WOKINGHAM
BOROUGH COUNCIL

Full Planning Approval Consultation

Site Address: 273 Loddon Bridge Road, Woodley, Wokingham, RG5 4BL

MEMORANDUM

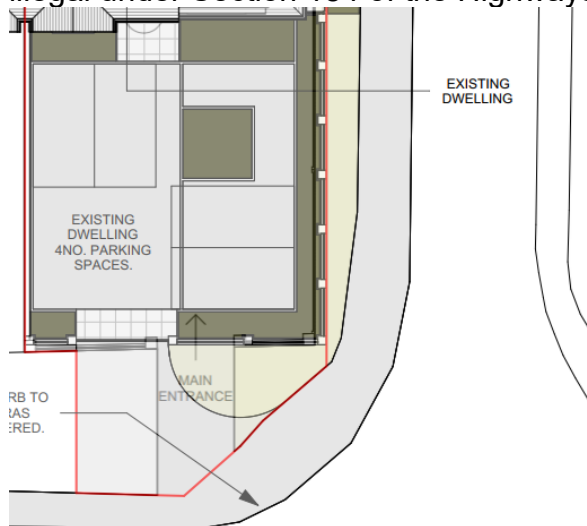
As the site is currently functioned as general amenity to the existing house, Highways have no objection on site sustainability for the proposal.

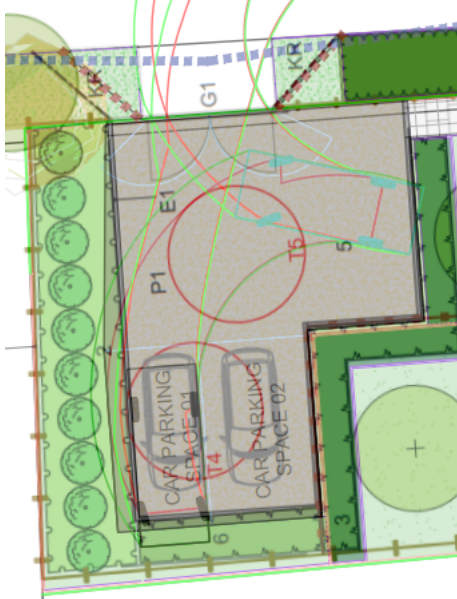
House B

The position of vehicular access for House B is identical to that of the western access approved in 251075, but the proposed driveway, parking arrangements and boundary treatment are to be amended. A new gate is proposed. The proposed driveway and access gate are different between plans. Clarification is required.

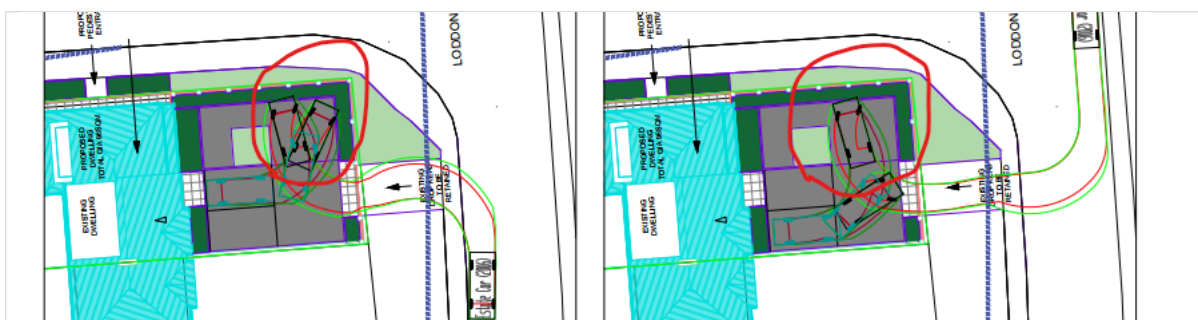
Cobham Road is subject to speed limits of 30mph, which requires visibility splays of 2.4m x 43m to be provided from the access onto Cobham Road. Any part of the proposed dwelling or boundary treatment also shall not reduce the visibility from the driveway of neighbouring properties. The sightlines shall be across land within the applicant's control or highway land and shall be clear of obstructions to visibility exceeding 0.6m in height.

The applicant has assessed the visibility splays of 2.4m x 33m and pedestrian visibility of 2m x 2m at the proposed accesses. However, the assessed visibility splays are insufficient. Part of the existing hazel hedge within the visibility splays will have to be removed.
